MONTGOMERY COUNTY HISTORIC PRESERVATION COMMISSION
STAFF REPORT

Address:	19120 Mateny Hill Road, Germantown	Meeting Date:	9/7/2022
Resource:	Master Plan Site #19/13-7A (<i>Wallich-Heimer House</i>)	Report Date:	8/31/2022
Applicant:	David Walter	Public Notice:	8/24/2022
		Tax Credit:	N/A
Review:	HAWP	Staff:	Michael Kyne

PROPOSAL: Outbuilding demo and new construction

Prefabricated shed

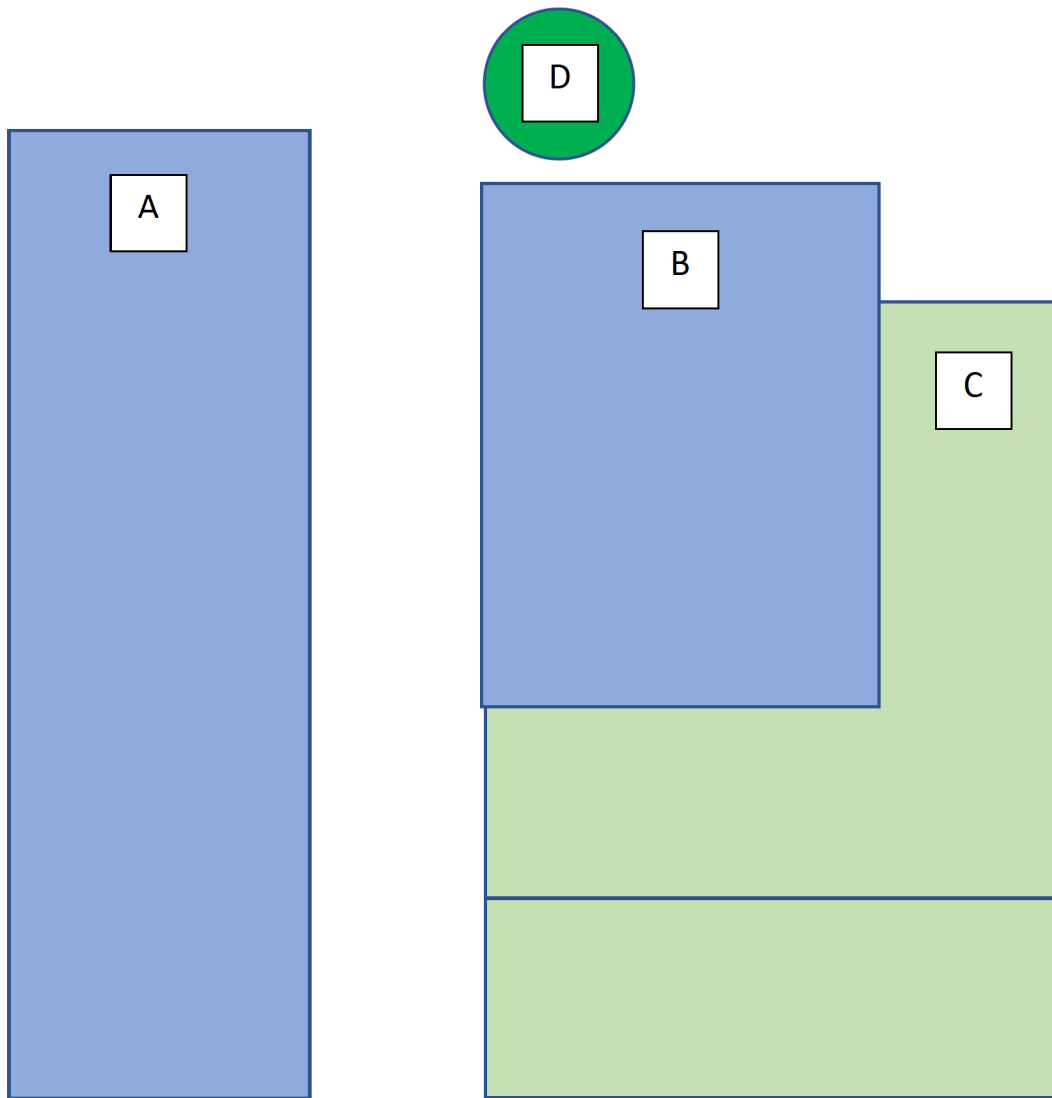
The subject property is the c. 1913 Colonial Revival-style *Wallich-Heimer House* Master Plan Site. There is a non-contributing shed at the west side (rear) of the house, which the applicant proposes to remove and replace with a new prefabricated shed in the same approximate location. The existing shed is 8.5' x 10.5', and the new shed will be 12' x 16'. The new shed will be constructed entirely from traditional materials, including painted wood siding, a painted wood porch (including posts, railings, and decking), painted wood windows, and a standing seam metal roof. A heat pump on 2' x 4' concrete pad is also proposed at the rear of the new shed.

Staff fully supports the applicant's proposal. The shed to be removed is a non-contributing outbuilding, and the proposed new shed is compatible in terms of location, scale and massing, and materials. Accordingly, staff finds that the proposal will not remove or alter features, spaces, or materials that characterize the subject property, per *Standards* #2 and #9.

Staff recommends that the Commission **approve** the HAWP application under the Criteria for Issuance in Chapter 24A-8(b), (1), (2), having found that the proposal will not substantially alter the exterior features of the historic resource and is compatible in character with the resource and the purposes of Chapter 24A;
